**BALLINA SHIRE COUNCIL**  
**WATER AND WASTEWATER DEVELOPMENT SERVICING PLANS**  
**PUBLIC EXHIBITION REPORT**  
**11 DEC 2014 – 15 JAN 2015**

### DRAFT DEVELOPMENT SERVICING PLAN FOR WASTE WATER AND RECYCLED WATER SUPPLY INFRASTRUCTURE SUBMISSION

### **DRAFT DEVELOPMENT SERVICING PLAN FOR WATER SUPPLY INFRASTRUCTURE SUBMISSION**

**RE: Submission to Public Exhibition of Draft DSP for Wastewater Services**

**BALLINA SHIRE COUNCIL**  
Sewerage Infrastructure – Development Servicing Plans  
May 2004

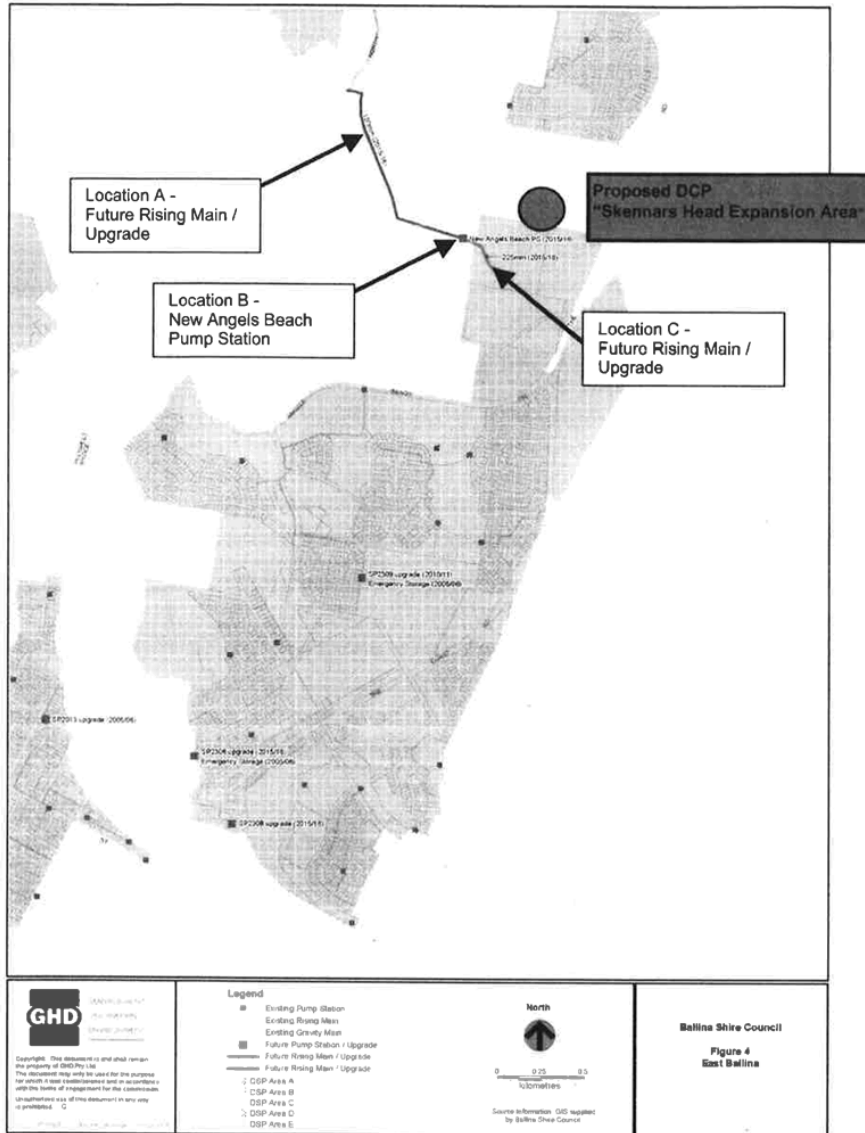
The current DSP for Sewerage Infrastructure - Figure 4 – East Ballina (Attachment 2) identifies the subject land is proposed to be serviced by a combination of future infrastructure. The future infrastructure is identified on the mark up on Figure 4 as:

- Location A – Future Rising Main / Upgrade;
- Location B – New Angels Beach Pump Station;

- Location C – Future Rising Main / Upgrade.

The designations of the sewerage infrastructure on Figure 4 demonstrates the nexus between the subject land (identified by mark up Proposed DCP “Skennars Head Expansion Area”) and the existing sewerage network. This “connection” of the subject land will be by the identified “Future” sewerage rising mains, and pump station (New Angels Beach PS 2015/16). These items are shown as marked up Location A, B and C.

- i. That the Draft Ballina Shire Council (BSC) Development Servicing Plan - Wastewater Infrastructure be amended to reflect the future infrastructure that is indicated in the current Ballina Shire Council Sewerage Infrastructure Development Servicing Plan – May 2004, particularly as indicated on Figure 4 – East Ballina, that demonstrates with future rising main / upgrades and future pump station / upgrades the connectivity between the existing sewerage infrastructure services and the proposed DCP Skennars Head Expansion Area land. The appropriate changes be made to the Draft DSP and all associated Figures.
- ii. That the Draft DSP be amended appropriately to ensure the subject land is included in section 3.3.1 – Future Development Areas, so that the terms in the description in the Draft DSP in the relevant part of section 3.3.1 be amended as follows:

Figure 4

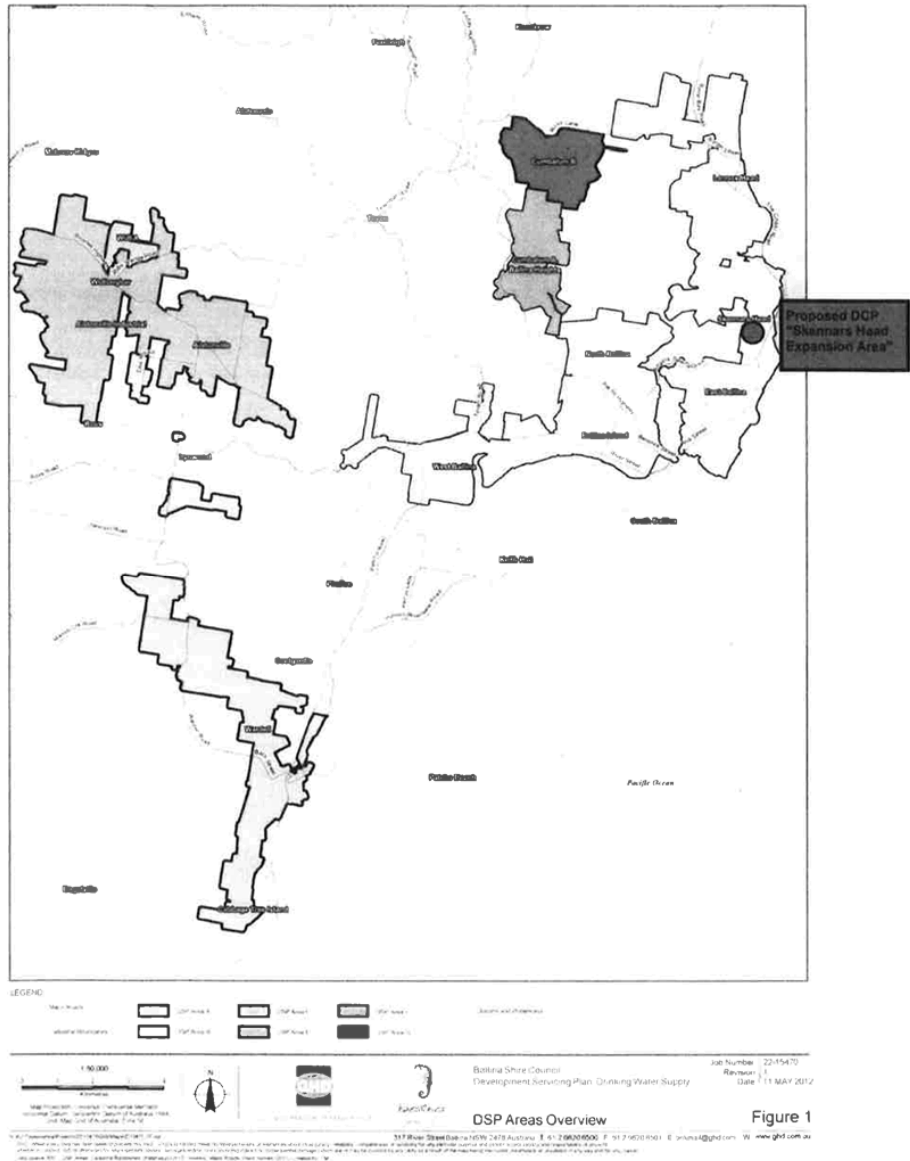
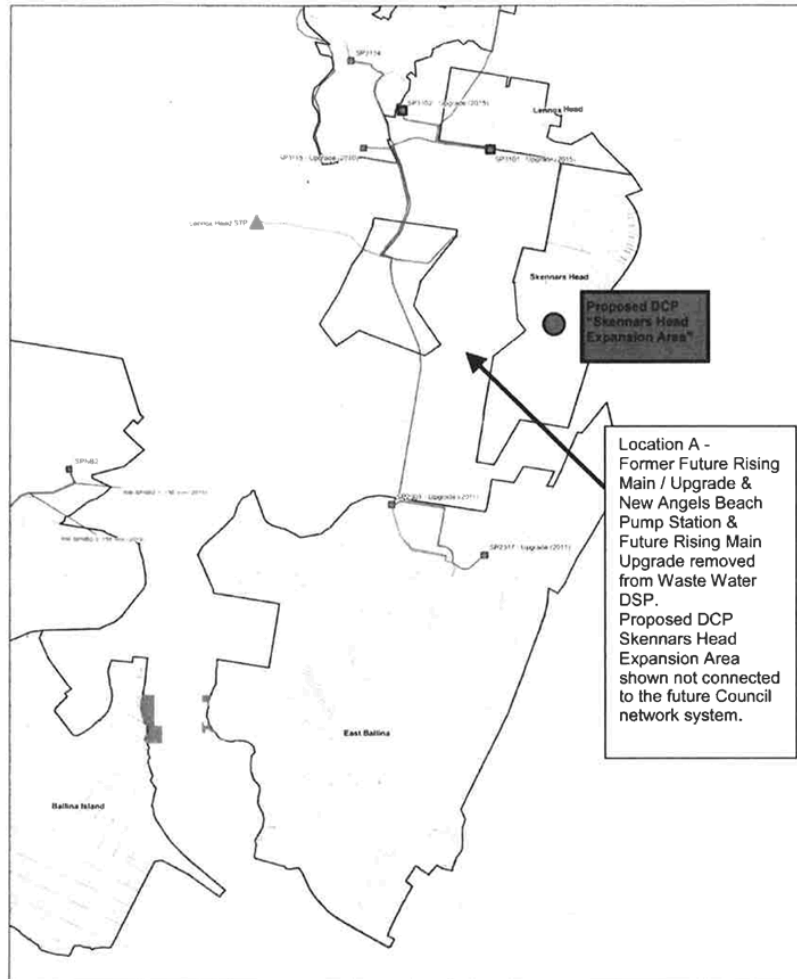
The subject land is situated within the Draft DSP Drinking Water Supply Figure 1 – DSP Areas Overview as DSP Area B. Refer Attachment 3. In further detail, the land is indicated as being situated within a DSP area in Figure 4 – DSP Area B South.

Draft Figure 4 as identified with the markup indicates Council has removed the following future infrastructure that is currently shown to service the subject land:

- Location A – Future Rising Main / Upgrade; New Angels Beach Pump Station; Future Rising Main / Upgrade.

- iii. The Draft DSP for Wastewater does recognise “a number of key development areas have been identified for future land supply in Ballina Shire”. One of these areas is identified as “Candidate Investigation Release Area in Skennars Head”. It is understood this incorporates the land the subject of this submission. This is reinforced by the subject land being contained within the DSP designated area Draft DSP Area B.
- iv. The fundamental difference between the existing DSP Sewerage Infrastructure and the Draft DSP for Wastewater is the fact the subject land is currently shown as being clearly serviced by future wastewater infrastructure. Refer to Figure 4 – East Ballina markups in particular those facilities identified in the mark up as Location A, Location B and Location C.

The removal of the infrastructure services from the Draft DSP in effect means there is now no surety in relation to the manner in which the subject land will be serviced in the future.

- viii. There is no justification provided in the Draft DSP for the removal of the sewerage infrastructure indicated in the current DSP to service the subject land.

**BALLINA SHIRE COUNCIL**  
Water Supply Infrastructure – Development Servicing Plans  
May 2004

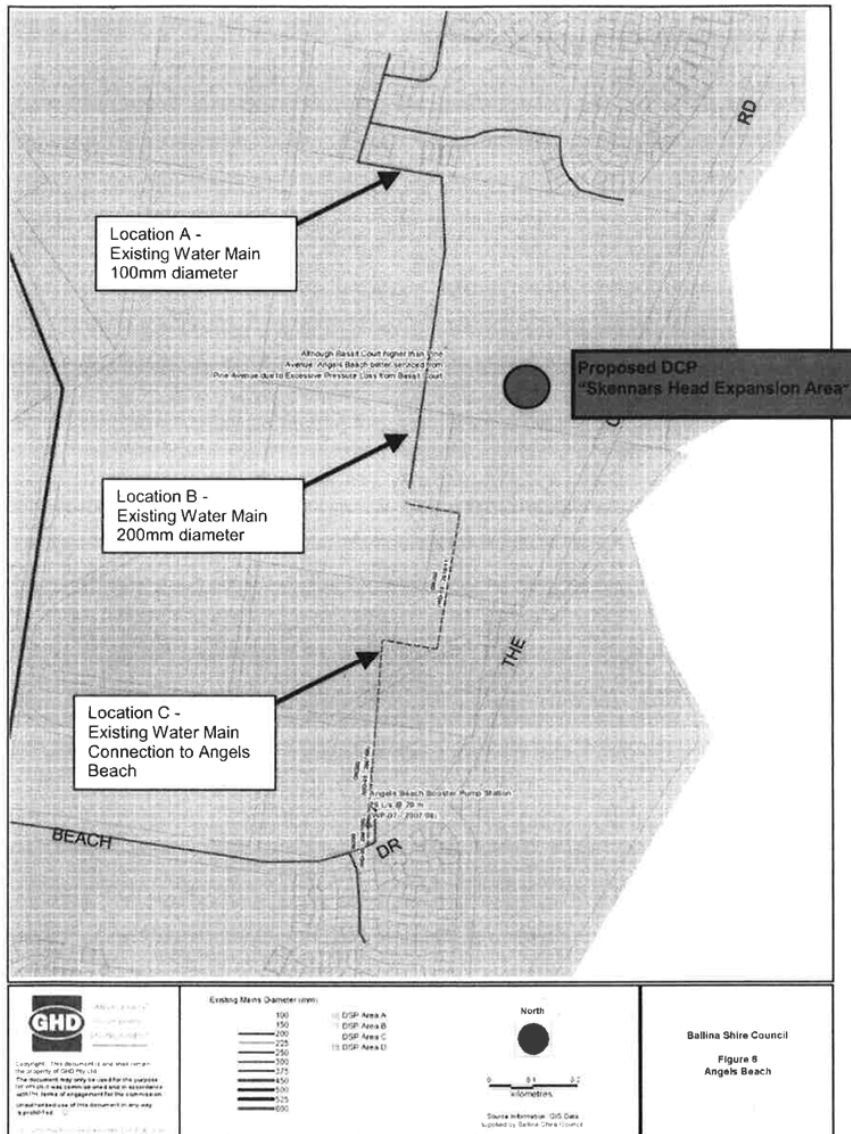
The current DSP for Water Supply Infrastructure - The Figure 6 – Angels Beach (Attachment 2) indicates there is an existing water main situated within the land. From investigations of Council's As Constructed information it is understood that part of the existing water main is a 100mm diameter water main and part of the existing water main is a 200mm diameter water main, as noted on the markup on Figure 6. This existing water main is also understood to be situated within an easement for water supply purposes. The current DSP for water supply indicates a

connection to the south, to the development known as "Angels Beach". This is designated on Figure 6 in a different line marking style.

The existing DSP identifies the existing water main in two (2) designations; one being existing mains, the other a dashed line indicating a connection to Angels Beach. This is shown in marked up figures in Attachment 2. The "dashed line" is not identified in the figure legend.

- vi. The designation of the existing water supply main in Figure 6 of the existing DSP Water Supply Infrastructure indicates the water supply main forms part of the DSP area and forms part of the water supply network for this part of the DSP Area B.

- i. That the Draft Ballina Shire Council (BSC) Development Servicing Plan for Water Supply Infrastructure be amended to reflect the designation of the existing trunk water supply infrastructure as a continuous existing trunk infrastructure water supply main throughout the subject site. In particular Figure 4 and Figure 5 of the Draft DSP be amended so the trunk infrastructure is shown for a continuous link and not part trunk infrastructure and part reticulation infrastructure. The appropriate changes be made to the Draft DSP and all associated Figures.
- ii. That the Draft DSP be amended appropriately to ensure the subject land is included in section 3.3.1 – Future Development Areas, so that the terms in the description in the Draft DSP in the relevant part of section 3.3.1 be amended as follows:

DRAFT Development Servicing Plan for Water Supply Infrastructure - December 2014

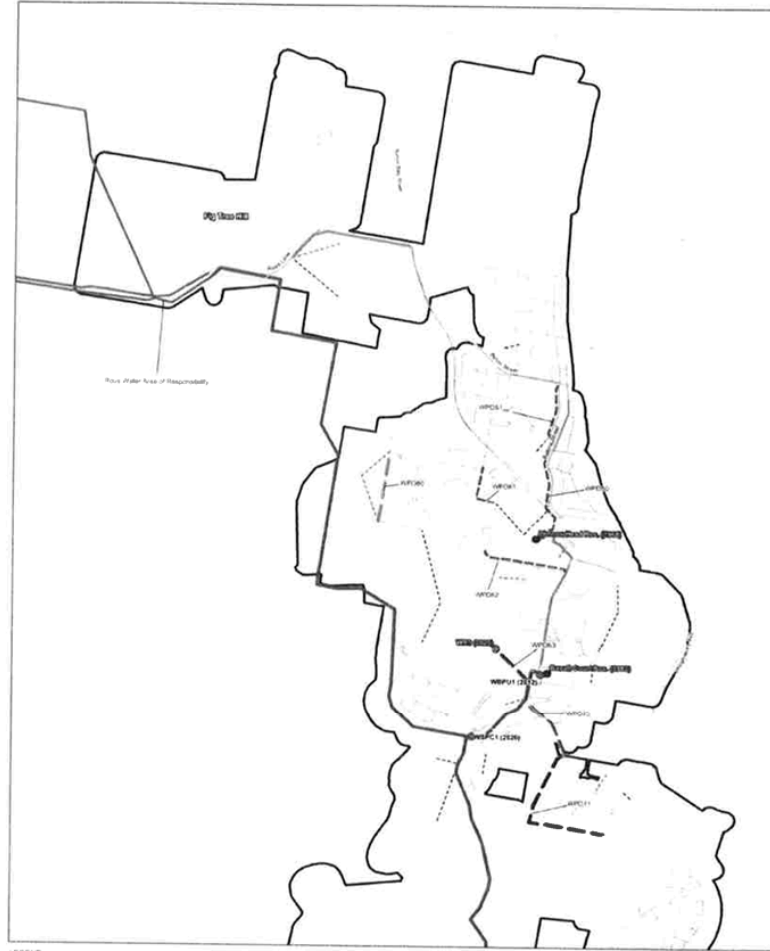
The subject land is situated within the Draft DSP Drinking Water Supply Figure 1 – DSP Areas Overview as DSP Area B. Refer Attachment 3. In further detail, the land is indicated in Figure 4 – DSP Area B South. The water supply infrastructure identified in the subject site and as shown on Figure 4 include the following (refer markup Attachment 3):

- Location A – Trunk Infrastructure (part);
- Location B – Reticulation Infrastructure (part);
- Location C – Developer Constructed Infrastructure (part);
- Location D – Trunk Infrastructure (part).

The Draft DSP for Water Supply changes the designations of the water supply main within the subject land to describe it as part trunk infrastructure, part reticulation infrastructure, and partly connected with developer constructed infrastructure. Refer to marked up sketch in Attachment 3.

- viii. The Draft DSP Water Supply Infrastructure attempts to provide a designation to "down grade" the functionality and requirements of this existing water supply main. That is, the Draft DSP for Water Supply Infrastructure amends the designation within the subject land to that shown on the marked up Figure 4 (Attachment 3). The draft designation now identifies this main as a combination of trunk infrastructure and reticulation infrastructure for varying lengths of the existing water supply main.

It is considered that such an apparent down grading of the water supply main is a specific attempt to remove the ability of the development of the land to claim any "works in kind" provisions.
